Staff Report

Case Number: VAR19-0006

Application Type: Variance

Location: 5521 S. Nevada St.
(west side of S. Nevada St., between W. Powers Ave. and W. Berry Ave.)

5521 S. Nevada St. Proposed Site Plan

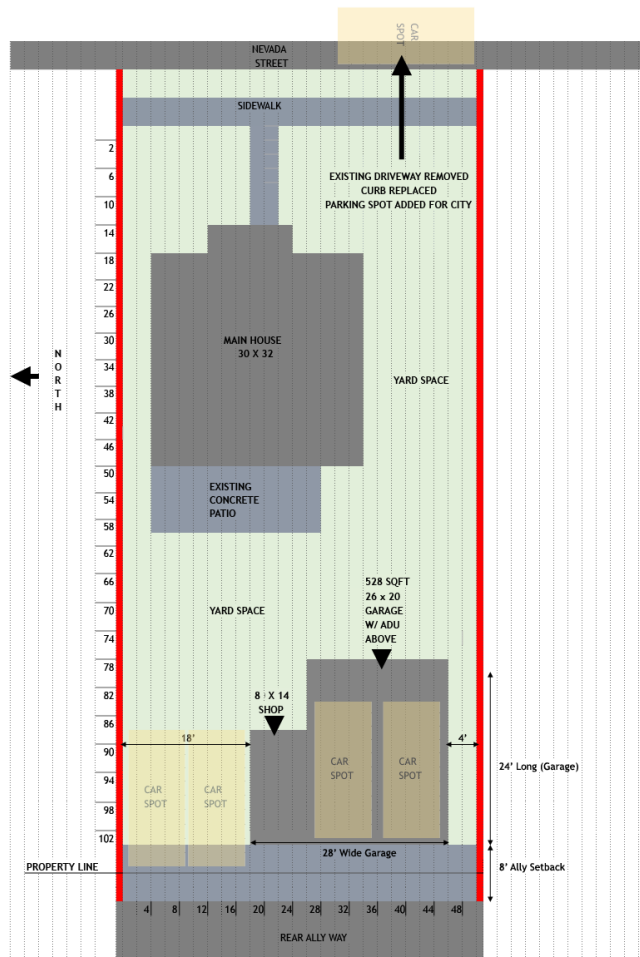
Staff appreciates the applicant's motives and reasoning for the proposed variances, however, the proposed variance would be better addressed as a citywide code change rather than on a lot-by-lot basis through the variance process. Although there may be several existing carriage houses in the older parts of Littleton, the question of whether two houses can be allowed on a single lot has potential wide-ranging effects on the character of the city and all its neighborhoods. In staff's opinion, carriage houses may be appropriate in the downtown area or other areas of the city, but there is nothing to indicate that this particular lot has a special circumstance which would warrant such variances.

The proposed variances to the setbacks are directly related to the additional house on the property. Granting a variance to the setback rules to accommodate a second house on the property could also alter the character of the neighborhood. Principal structures are allowed a height of 30 feet in the R-5 zone where a detached garage is limited to 18 feet. The higher structure may warrant a greater rear setback to maintain consistency with the surrounding character. In staff's opinion, the proposed variances are not consistent with this criterion.

From the site plan provided, it may be possible for the applicant to add on to the existing house to make two units without need for any variances. If the object is to have two houses on this property, then it is staff's opinion that the proposed variances are not consistent with this criterion.

Although staff appreciates the applicant's goals, staff recommends denial of the proposed variances related to the detached garage with a dwelling unit reflected as Exhibit A to the resolution. Allowances for accessory dwelling units should be addressed through a code amendment for all citizens, not by variance for individual lot owners.

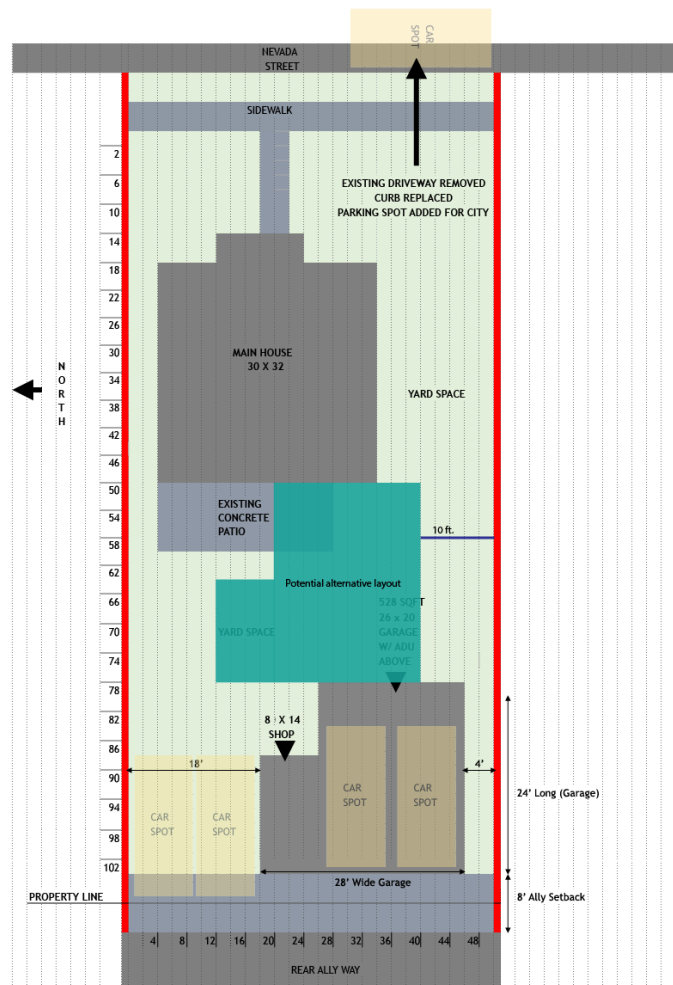
The modified site plan shown on this page illustrates how a similar sized addition may be possible. It should be noted that the proposed site configuration does not take into account structural modifications, consistency with downtown design standards, potential building and fire code requirements (for instance, fire rated party walls), or more complicated construction for moving doors, windows, etc. Regardless, staff's analysis indicates that attachment to the existing primary structure remains an option; therefore, it is questionable if a second single-family detached structure is the minimum that will afford relief.
